HDEP Cylinder Head Gasket Sealing Issues

FIELD SOLUTION: Replace liner(s) on cylinder(s) with a confirmed compression seal leak on the head gasket

VISUALIZATION:

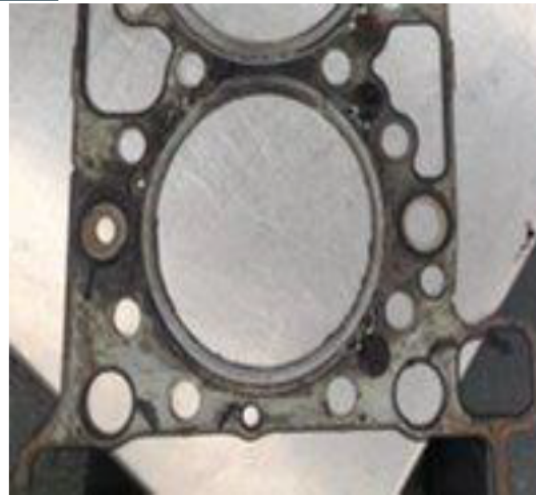
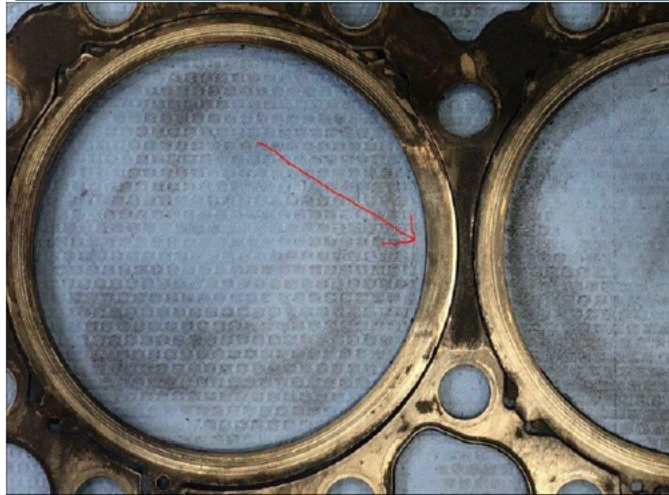
- Customer complaint will be a coolant leak at the block/head joint.

- Quality has identified the cause of the head gasket failures is being caused by the improper machining of the liner flange and the failure of the compression seal.

- Progressive damage from CGL is also causing an increased amount of cylinder head replacements due to damage to the fire deck surface.
- Comparison between BOB and WOW engines show no contrast in liner protrusion measurements.
- Inspection results from the supplier show no deviation in bead height measurements on failed cylinder head gaskets.
- Concentration diagram is showing lowest count of failures between cylinder #4 and cylinder #5. Fuji paper test and instrumented bolt test planned to investigate clamp load.
- FEA deep dive and non-nominal FEA analysis requested.
